February 19, 2009

Subject: Response to USEPA Comments on the *Draft Background Study Work Plan* for Naval Weapons Station, Yorktown, Yorktown, VA and Cheatham Annex, Williamsburg, VA

**Table 5-1
Summary of Background Study
Wells to be Sampled**

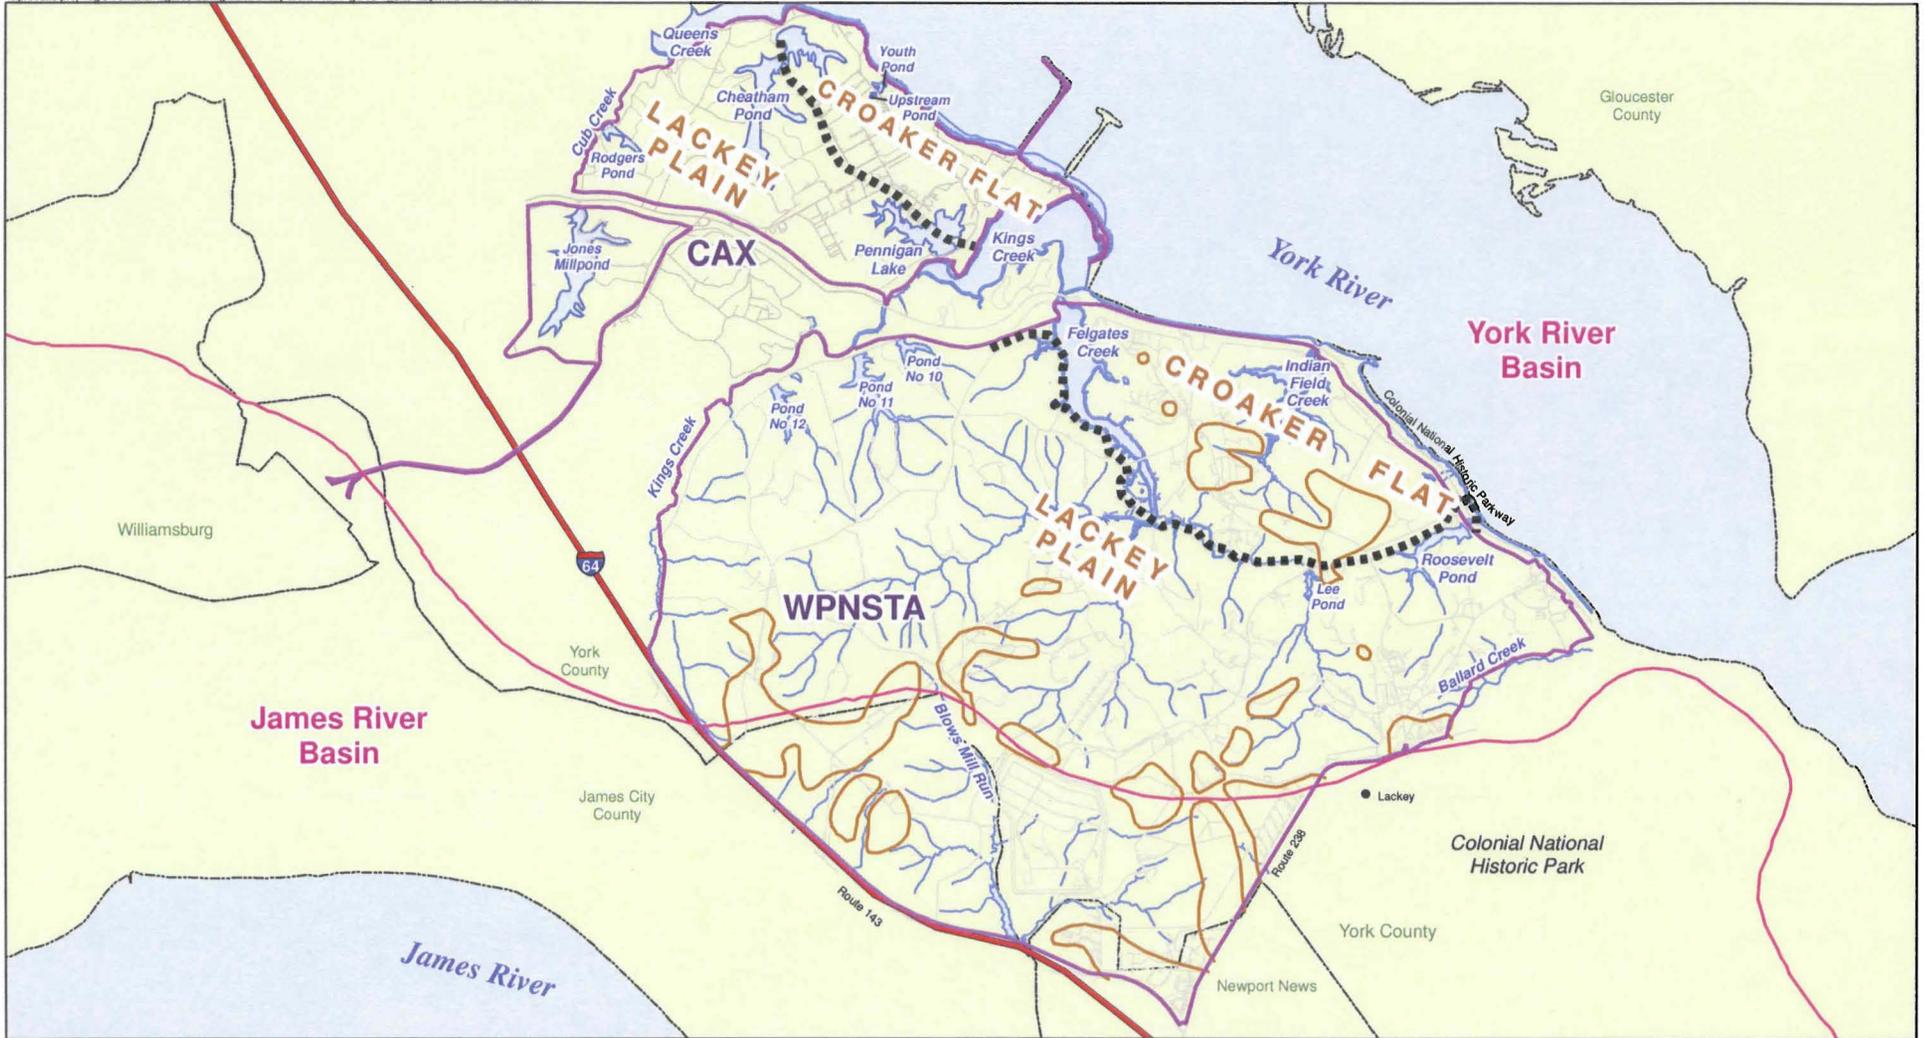
- *The list of existing wells which will be sampled for collection of groundwater background data has not been provided in the text, and well locations depicted on Figure 5-2 are*

referenced as 'E', 'G', 'H', and 'N' wells. It is unclear if these references are the full name of the wells or just abbreviations. For clarity and completeness, please revise the Work Plan to include a listing of all the wells to be sampled.

Navy Response: The references to "E, G, H, etc." are the designations assigned by the USGS for their shallow aquifer system study at Naval Weapons Station Yorktown (Brockman et al, 1997). The Navy agrees that this reference is not clear in the text. The text (Section 5.1, third paragraph) will be revised as follows (new text is underlined):

"To ensure a minimum of ten representative background samples are available for each aquifer, a total of 15 samples will be collected in the Cornwallis Cave aquifer and a total of 13 samples will be collected in the Yorktown-Eastover aquifer. The samples will be collected from the existing background and USGS wells except for three. Two new background wells are proposed for the Yorktown-Eastover aquifer (BGGW09A and BGGW10A), and one new well in the Cornwallis Cave aquifer (BGGW10) to ensure adequate sample size for statistical analyses. Additionally, the new wells will provide groundwater quality data on Croaker Flat, to supplement the existing wells installed on the Lackey Plain. The location of CERCLA sites and the existing and proposed new background monitoring wells are shown on Figures 5-1 (Cornwallis Cave aquifer) and 5-2 (Yorktown-Eastover aquifer). Table 5-1 provides a listing of all wells to be sampled, including aquifer and well designations."

A copy of Table 5-1 is provided as an attachment to this letter.

Figure 2-1
Site Map
 Background Study Work Plan
 Naval Weapons Station Yorktown
 Yorktown, Virginia

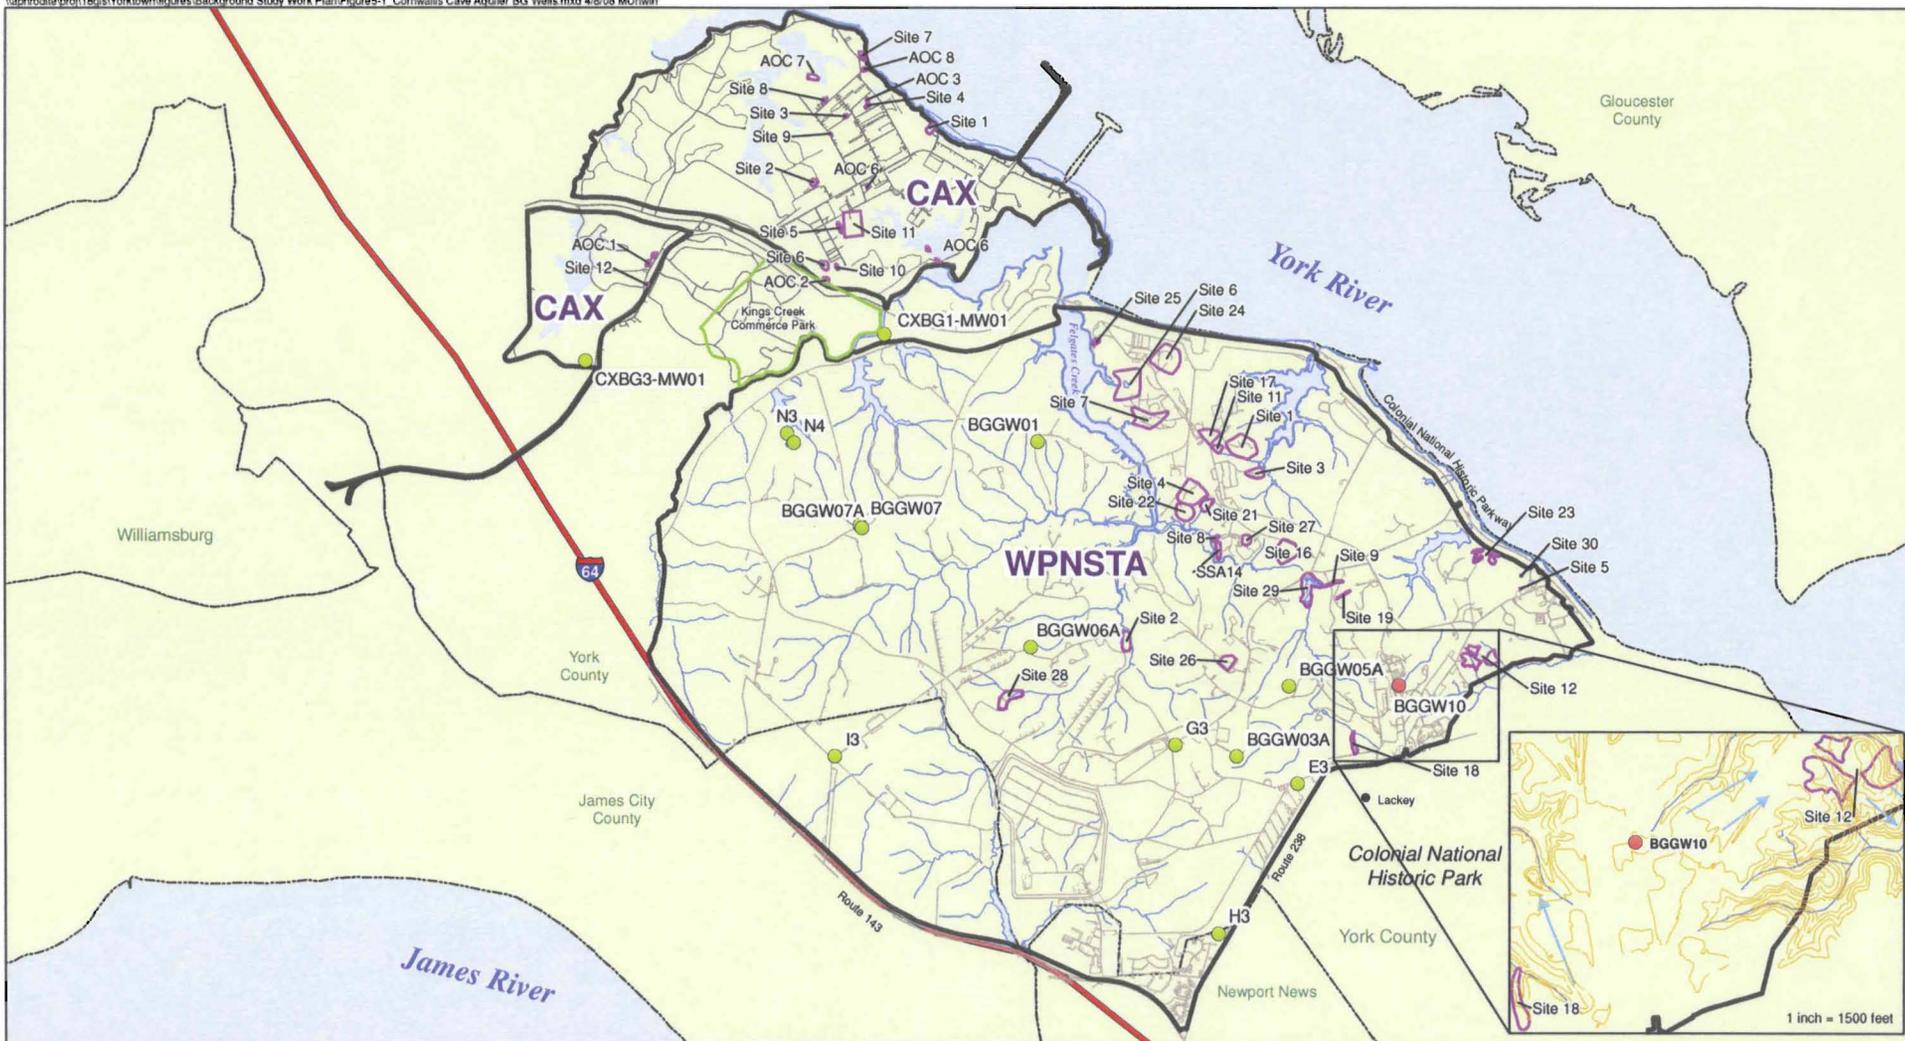
- 4. Section 2.2.1, WPNSTA Yorktown, Page 2-3:** *This section references two surface water features that are located within the site boundaries but which are not labeled on Figure 2-1, Site Map. These include Pond 10 and Lee Pond. So that a complete understanding of the site hydrologic features can be obtained from the text and figure, it is recommended that these two ponds be labeled on the Site Map.*

- 5. Section 2.2.2, CAX, Page 2-3:** *Two man-made ponds, referred to in the text as Youth Pond and Catfish Pond have not been depicted on Figure 2-1, Site Map. Although it is understood that these ponds are one to two acres in size, it is recommended that these ponds be depicted on the Site map so that a complete understanding of the site hydrologic features can be obtained.*

Navy Response: Agreed. Figure 2-1 has been revised to included labels for the Pond 10 and Lee Pond surface water features. A copy of the revised figure is included as an attachment to this letter.

Navy Response: Agreed. Figure 2-1 has been revised to included labels for the Youth Pond and Rodgers Pond surface water features. In addition, the upstream pond (upstream of Youth Pond) has been noted and a reference to it added to the text, as shown below. (Note: The reference to “Catfish Pond” was in error. There is no Catfish Pond at CAX; it is instead known as Rodgers Pond.)
